# Archive ENERGY STAR Single-Family New Homes Policy Record

## Archive ENERGY STAR Single-Family New Homes Policy Record

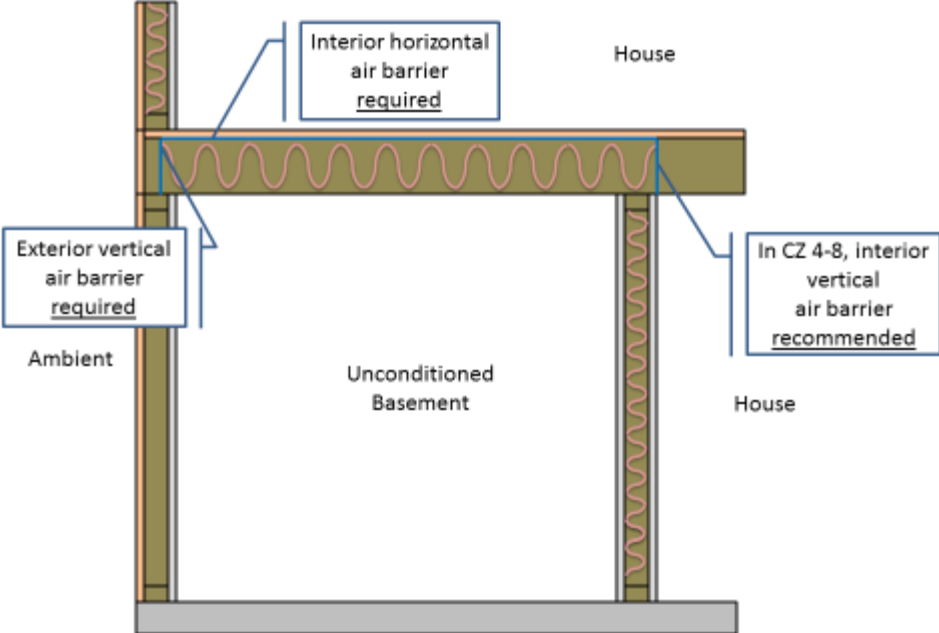
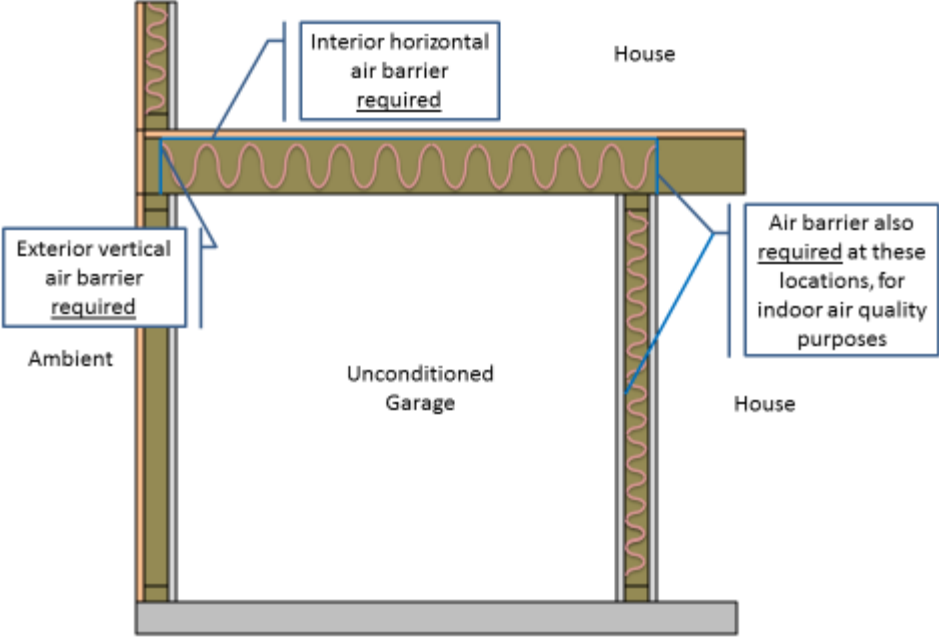
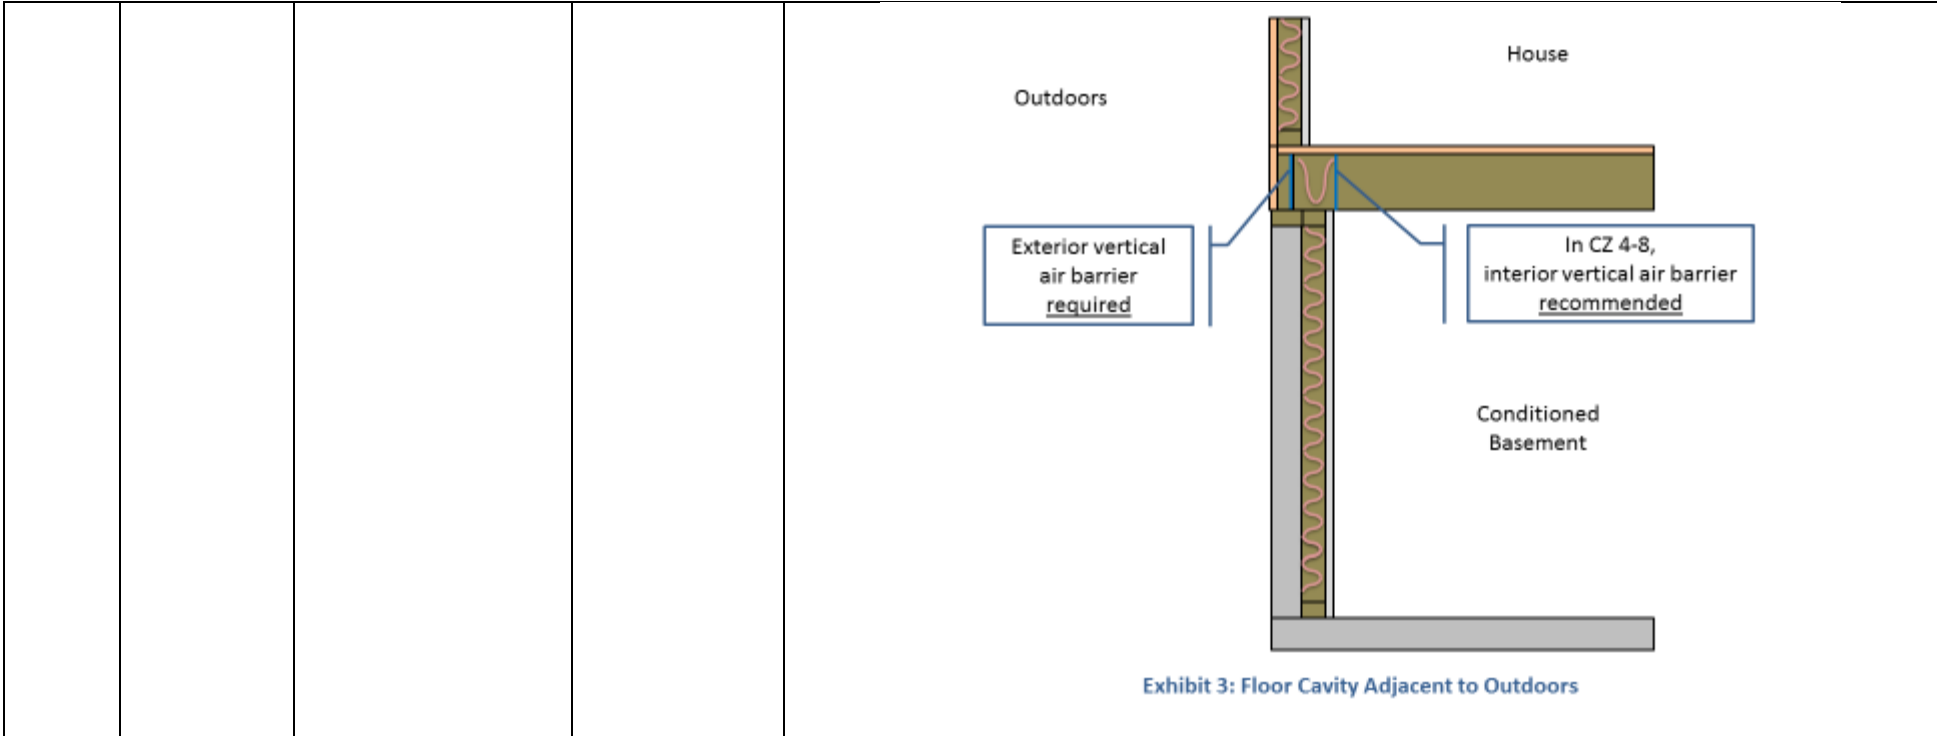
00467	07/01/2015	Thermal Enclosure System Rater Checklist (Version 3, Rev. 07)	Clarification	<b>Section 3, Footnotes 8 &amp; 9 – Clarified intent of air barrier configurations</b>
				<b>Issue:</b> Partners have asked for clarification regarding several aspects of the requirements for fully-aligned air barriers in Section 3, including: <ul style="list-style-type: none"> <li>• What the required orientation of the air barrier is for each assembly type (i.e., horizontal, vertical, or both),</li> <li>• Whether the requirements for walls in Item 3.1 actually also encompass rim joists and other floor cavities.</li> </ul>

<p>Partners have also noted several inconsistencies in the terminology used throughout Section 3 and its Footnotes, such as “blocking at exposed edge”, which simply implies a vertical air barrier at the exterior surface of the insulation.</p> <p><b>Resolution:</b> To clarify the intended orientation of the air barrier for each assembly type, Section 3 will be edited to distinguish between vertical and horizontal air barriers for ceilings, walls, and floors, as well as to define the required locations of the air barriers relative to the surface of the insulation. The requirements for each component type (i.e., ceiling, walls, and floors) will be grouped with the details associated with that component (e.g., ceiling requirements will be grouped with the list of ceiling details that must be inspected).</p> <p>The requirements for floors will be clarified by:</p> <ul style="list-style-type: none"> <li>- Relocating all floor details into the Floors Section</li> <li>- Clarifying that an air barrier is always required at the exterior vertical surface of floor insulation</li> <li>- Clarifying that an air barrier is also required at the interior horizontal surface of the floor insulation, if located over unconditioned space.</li> <li>- Clarifying that an air barrier is recommended, but not required, at the interior vertical surface of all floor insulation in CZ 4-8.</li> </ul> <p>In addition, the language regarding wind baffles at ceiling insulation will be made more consistent.</p> <p>Finally, the phrase, “blocking at exposed edge” in the section on floors will be rephrased as a requirement for an air barrier at the “exterior vertical surfaces of floor insulation”. The revised language in Section 3 will be as follows:</p> <p>“At each insulated location below, a complete air barrier shall be provided that is fully aligned as follows:</p> <ul style="list-style-type: none"> <li>• <u>Ceilings:</u> At interior or exterior horizontal surface of ceiling insulation in Climate Zones 1-3; at interior horizontal surface of ceiling insulation in Climate Zones 4-8. Also, at exterior vertical surface of ceiling insulation in all climate zones (e.g., using a wind baffle that extends to the full height of the insulation in every bay or a tabbed baffle in each bay with a soffit vent that prevents wind washing in adjacent bays)</li> <li>• <u>Walls:</u> At exterior vertical surface of wall insulation in all climate zones; also at interior vertical surface of wall insulation in Climate Zones 4-8</li> </ul>

<ul style="list-style-type: none"> <li>• <u>Floors</u>: At exterior vertical surface of floor insulation in all climate zones and, if over unconditioned space, also at interior horizontal surface including supports to ensure alignment. See Footnotes 10 and 11 for alternatives”</li> </ul> <p>The following details within each section will be modified:</p> <p>Walls:</p> <ul style="list-style-type: none"> <li>• Item 3.1.5 will be revised to state, “Walls <u>adjoining porch roofs or garages</u>”</li> <li>• Item 3.1.8, garage rim / band joist adjoining conditioned space, will be deleted and a new Item added to the Floors Section to address this detail.</li> </ul> <p>Floors:</p> <ul style="list-style-type: none"> <li>• A new Item will be added to address rim / band joists and other floors that are adjoining unconditioned space: “<u>All other floors adjoining unconditioned space (e.g., rim / band joists at exterior wall or at porch roof)</u>”</li> </ul> <p>Per Policy Record Entry 00428, Footnotes 7 &amp; 10 will be merged and renumbered to improve clarity and reflect new exemptions to the requirement for interior air barriers in basements. This new Footnote will be further modified as follows:</p> <p>“All insulated vertical surfaces are considered walls (e.g., above and below grade exterior walls, knee walls) and must meet the air barrier requirements for walls. The following exceptions apply: air barriers recommended, but not required, in adiabatic walls in multifamily dwellings; and, in Climate Zones 4 through 8, an air barrier at the interior vertical surface of insulation is recommended but not required in basement walls or crawlspace walls. For the purpose of these exceptions, a basement or crawlspace is a space for which <math>\geq 40\%</math> of the total gross wall area is below-grade.”</p> <p>In addition, Footnote 7, which recommends the inclusion of an interior air barrier at rim / band joists in Climate Zones 4 through 8, will be refined to reflect this new policy and moved to Footnote 9 of the Rater Field Checklist, as follows:</p> <p>“EPA highly recommends, but does not require, an air barrier at the interior vertical surface of floor insulation in Climate Zones 4-8.”</p> <p>Exhibits 1 through 4 illustrate the clarified policy for floors.</p> <p>In Exhibit 1, the floor is adjacent to the outdoors and over an unconditioned basement. An air barrier is therefore required at the exterior vertical surface of the floor insulation and at the interior horizontal surface of the insulation. In addition, if the home was in CZ 4-8, an air barrier would also be recommended, but not required, at the interior vertical surface of the insulation.</p>

<p data-bbox="1234 852 1690 901"><b>Exhibit 1: Floor Cavity Adjacent to Outdoors &amp; Over Unconditioned Basement</b></p> <p data-bbox="898 925 1969 1079">Exhibit 2 illustrates a similar configuration, except that the floor is located over an unconditioned garage. In this case, the same air barriers are required for thermal purposes. However, for indoor air quality purposes, an air barrier is also required at the wall that separates the attached garage from occupiable space and, also, an air barrier must be installed and sealed at the floor cavity aligned with this wall.</p>
--	--	--	--	---

Exhibit 5: Floor Cavity Adjacent to & Over Outdoors

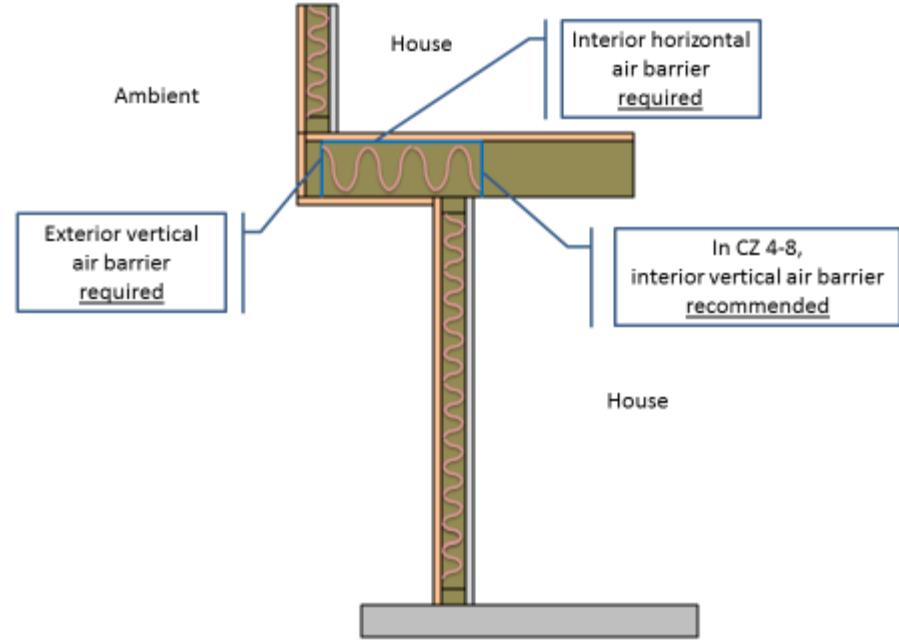
<p><b>Exhibit 4: Floor Cavity Adjacent to Unconditioned Porch Roof</b></p> <p>In Exhibit 5, a cantilever configuration is illustrated, in which the floor is both adjacent to and over the outdoors. Therefore, an air barrier is required at the exterior vertical surface of the insulation and at the interior horizontal surface of the insulation. If the configuration was located in CZ 4-8, then an interior vertical air barrier would also be recommended. Finally, as a best practice, an air barrier would also be included at the exterior horizontal surface of the insulation.</p>
--	--	--	--	---

Footnote 8, which provides the alternative compliance option of completely filling a floor cavity in lieu of using insulation supports (e.g., staves, netting), will be revised by removing references to air barriers because the requirements are not intended to be any different when this alternative is used:

00114	01/15/2012		Comment	<b>Item 3.1.1 – Use of Thermoply as an air barrier</b>

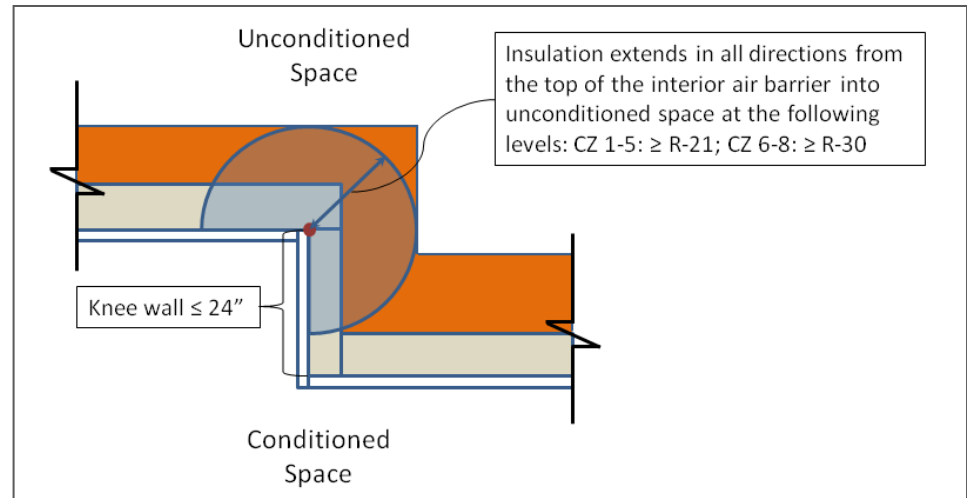
<b>Thermal Enclosure System Rater Checklist (Version 3, Rev. 04)</b>		<p><b>Issue:</b> Partners have asked if Thermoply can be used as an air barrier behind tubs and showers to meet the intent of Item 3.1.1, which requires fully-aligned air barriers at walls behind showers and tubs.</p> <p><b>Resolution:</b> Rigid air barriers, including Thermoply, may be used to comply with Item 3.1.1, per Footnote 6: “For purposes of this Checklist, an air barrier is defined as any durable solid material that blocks air flow between conditioned space and unconditioned space, including necessary sealing to block excessive air flow at edges and seams and adequate support to resist positive and negative pressures without displacement or damage.”</p> <p>Note, however, that Thermoply does not satisfy the intent of Item 4.2 of the Water Management System Builder Checklist, which requires that cement board or equivalent moisture-resistant backing material be installed on all walls behind tub and shower enclosures composed of tile or panel assemblies with caulked joints. Therefore, if Thermoply is used where such enclosures are located adjacent to exterior walls, it must be coupled with a moisture-resistant backing material to meet the intent of both Items.</p>

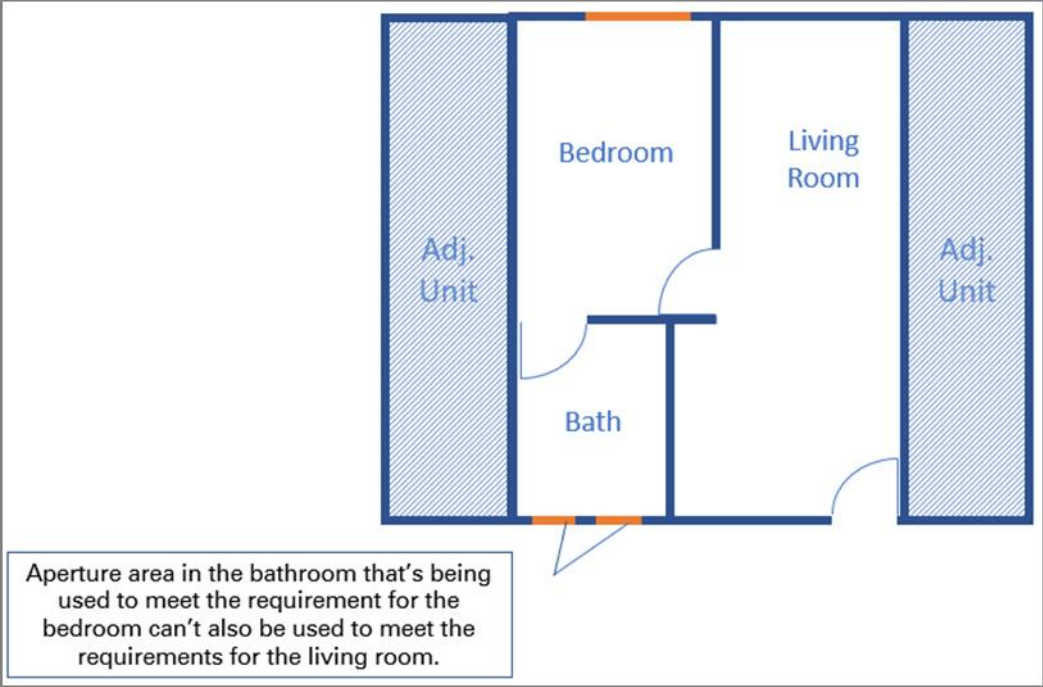
00680	06/29/2018	Rater Design Review Checklist for the Tropics (Version 3, Rev. 08)	Change	<p><b>Item 2.2.4 - Increased tolerance for window area used in HVAC Design Report</b></p> <p><b>Issue:</b> Partners have noted two issues with the allowable tolerance between the window area used in loads and that of the home to be certified.</p> <p>The first issue is that the low-end tolerance does not permit the window area used in the loads to be any smaller than the home to be certified, even when such a deviation will not significantly affect the load. For example, if the designer calculates the load with even one less sq. ft. of window area than what the home to be certified contains (e.g., due to an imprecise take-off), then the home would not strictly meet the intent of this item.</p> <p>The second issue is that as the window area in the home increases, the fixed tolerances become increasingly restrictive. That is to say, while the high-end tolerance of 60 sq. ft. may be routinely achievable for a typical home, as the window area increases the 60 sq. ft. tolerance becomes a smaller percentage of the overall window area.</p> <p>Outreach was conducted with multiple partners in different climate zones. Partners indicated that it would be helpful to increase the low-end tolerance to allow the window area used in the loads to be slightly smaller than the home to be certified. Partners also indicated that adding a percent-based tolerance would be helpful to address the second issue.</p> <p><b>Resolution:</b> The tolerance will be changed to allow the window area used in loads to fall between 15 sq. ft. smaller and 60 sq. ft. larger than the home to be certified. This change recognizes that if the window area used in the load calculations is slightly smaller than the home to be certified, the overall accuracy of the load will not be greatly compromised. Additionally, for homes to be certified with greater than 500 sq. ft. of window area, the tolerances will be changed to use a percentage of window area.</p>

<p>To reflect this change, Item 2.2.4 will be revised to read:</p> <p>“Window area used in loads (3.6) is between 15 sq. ft. smaller and 60 sq. ft. larger than the home to be certified, or, for homes to be certified with &gt; 500 sq. ft. of window area, between 3% smaller and 12% larger”</p>
00914	11/01/2019	Tropics Rater Design Review Checklist (Version 3, Rev. 09)	Clarification	<p><b>Item 2.2.3 &amp; 2.2.4 - Guidance added on how to determine conditioned floor area and window area</b></p>
				<p><b>Issue:</b> Items 2.2.3 and 2.2.4 currently do not include guidance on how a Rater should calculate “Conditioned Floor Area” and “Window Area”, which could cause inadvertent discrepancies between the values determined by them and by HVAC designers on the HVAC Design Report.</p>
				<p><b>Resolution:</b> Raters are required to calculate these values using ANSI / RESNET / ICC Standard 301-2019.</p> <p>A new footnote will be added to Item 2.2.3 as follows:</p> <p>“Conditioned Floor Area for the home to be certified shall be calculated in accordance with the definition in ANSI / RESNET / ICC Standard 301-2019.”</p> <p>A new footnote will be added to Item 2.2.4 as follows:</p> <p>“Window area for the home to be certified shall be calculated in accordance with the on-site inspection protocol provided in Normative Appendix B of ANSI / RESNET / ICC Standard 301-2019.”</p>

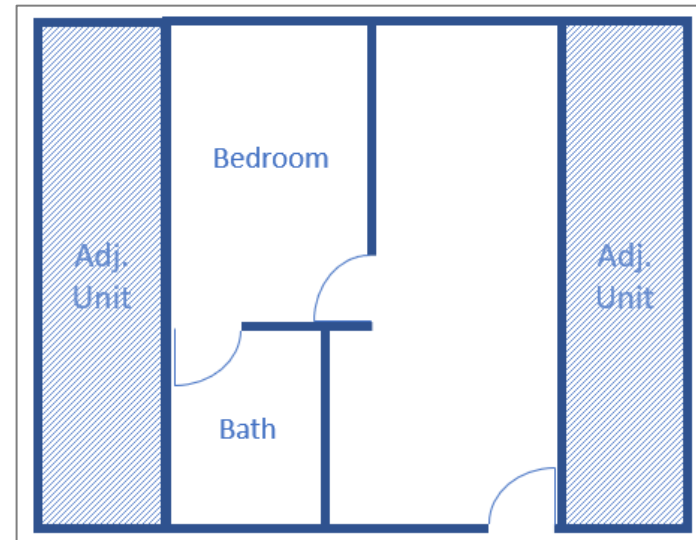
00961	08/07/2020	Caribbean & Pacific Rater Design Review Checklist (Version 3, Rev. 10)	Clarification	<b>Item 4.1.1 – Only screened portions of exterior doors count as operable aperture area</b>
				<p><b>Issue:</b> Partners have asked whether the entire opening of an exterior door, or just the subset that is screened, can be used in the calculation of operable aperture area for primary living areas.</p> <p><b>Resolution:</b> Per Item 4.1.4, insect screens must be specified for all components that contribute to the operable aperture area. Therefore, only the screened portion of exterior doors is permitted to be used when calculating the operable aperture area. For example, if the exterior door is partially screened or if there is a screen door in addition to the main exterior door, then the screened portion can contribute to the operable aperture area.</p>
00959	08/07/2020	Caribbean & Pacific Rater Design Review Checklist (Version 3, Rev. 10)	Clarification	<b>Item 4.1.1 – Aperture area cannot be ‘double-counted’</b>

<p><b>Issue:</b> This Item requires, in part, that for all primary living areas, operable aperture areas totaling a minimum of 12% of the floor area of the room be specified in that room. While implied, the program requirements do not currently state explicitly that aperture area used to meet the requirements for one primary living area shall not also be used to meet the</p>

<p>requirements for a second primary living area (i.e., the aperture are cannot be double-counted).</p> <p><b>Resolution:</b> To prevent potential confusion or misinterpretation, this intent will be explicitly stated. The intent is illustrated below:</p>  <p>To reflect this intent, the following sentence will be added to the beginning of Footnote 14, which is referenced by Item 4.1.1:</p> <p>“Aperture area used to meet the requirements for one primary living area shall not also be used to meet the requirements for a second primary living area.”</p>
00960	08/07/2020	Caribbean & Pacific Rater Design Review Checklist (Version 3, Rev. 10)	Clarification	<p><b>Item 4.1.3 – Apertures allowed outside primary living area in some cases</b></p> <p><b>Issue:</b> Partners have asked whether this Item, which defines requirements for aperture location, requires apertures to be on walls that directly bound the primary living area and, if not, whether additional requirements apply to those outside the primary living area.</p>

**Exhibit 2**

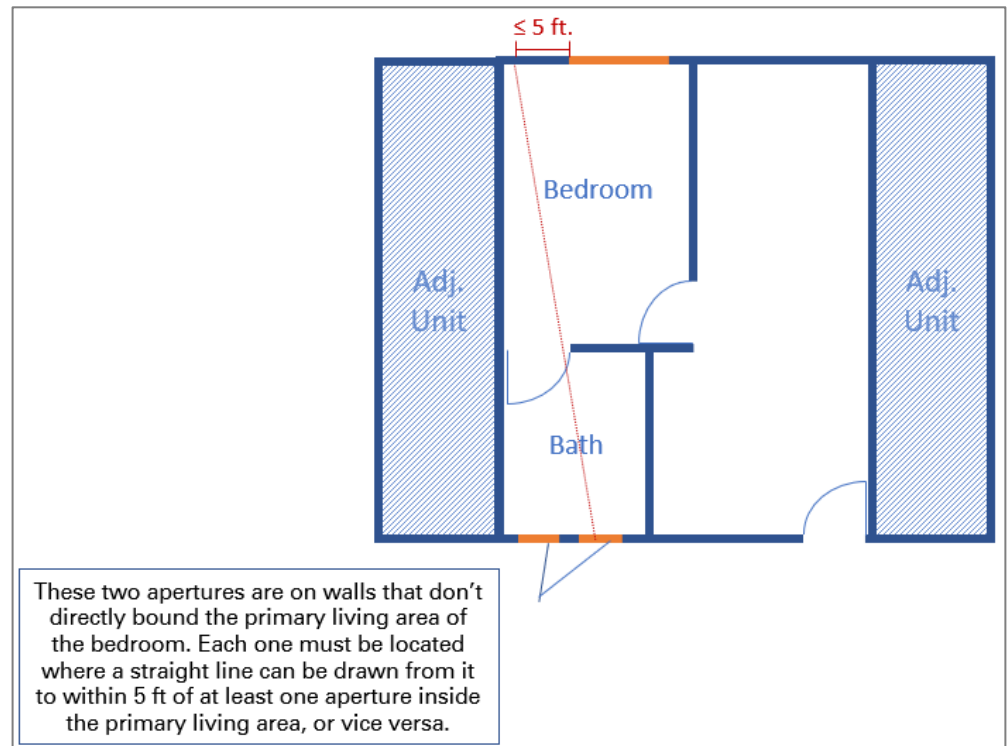
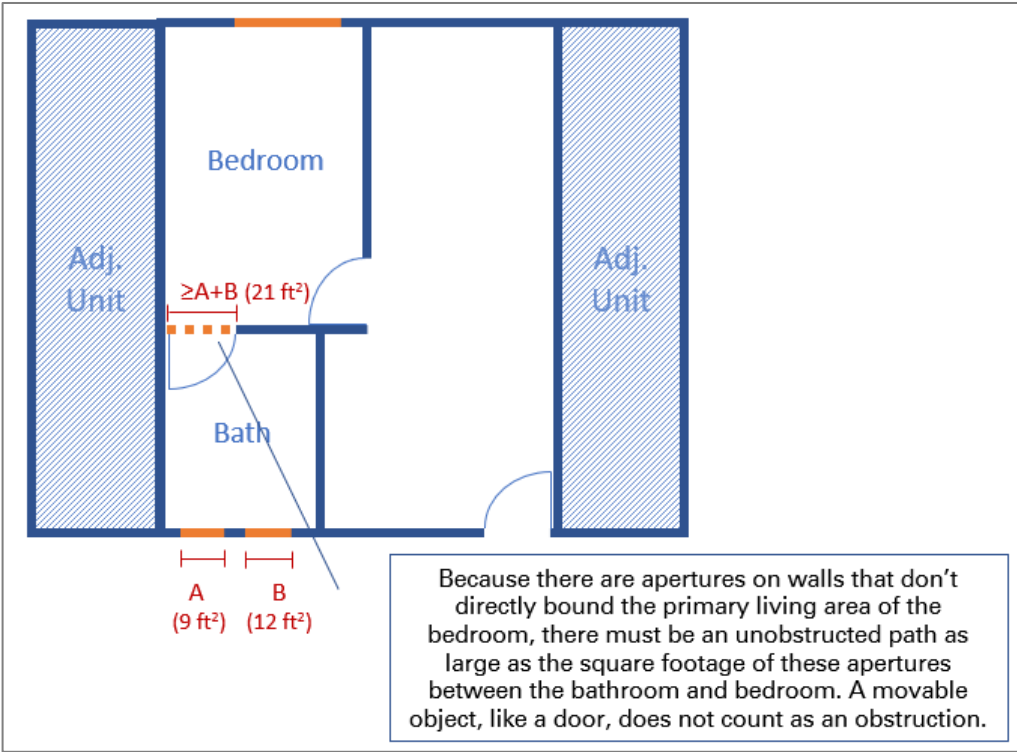
**Resolution:** Clarifying the requirements for aperture location will promote consistent implementation of the program requirements, while adding a pragmatic allowance that does not alter the original intent of the requirements.

Apertures will be allowed to be located outside the primary living area if they meet two prerequisites that promote effective natural ventilation. Namely, the apertures outside the primary living area must be effectively aligned with at least one aperture inside the primary

living area. More effective ventilation should be promoted by not allowing circuitous or obstructed routes between apertures.

Specifically, this intent can be conveyed by recommending, but not requiring, apertures to be on walls that directly bound the primary living area.

Furthermore, apertures outside the primary living area can be required to be “effectively aligned” with at least one aperture inside the primary living area, where an aperture is “effectively aligned” if a straight line can be drawn from one aperture to within 5 ft. of the other aperture. See Exhibit 2.
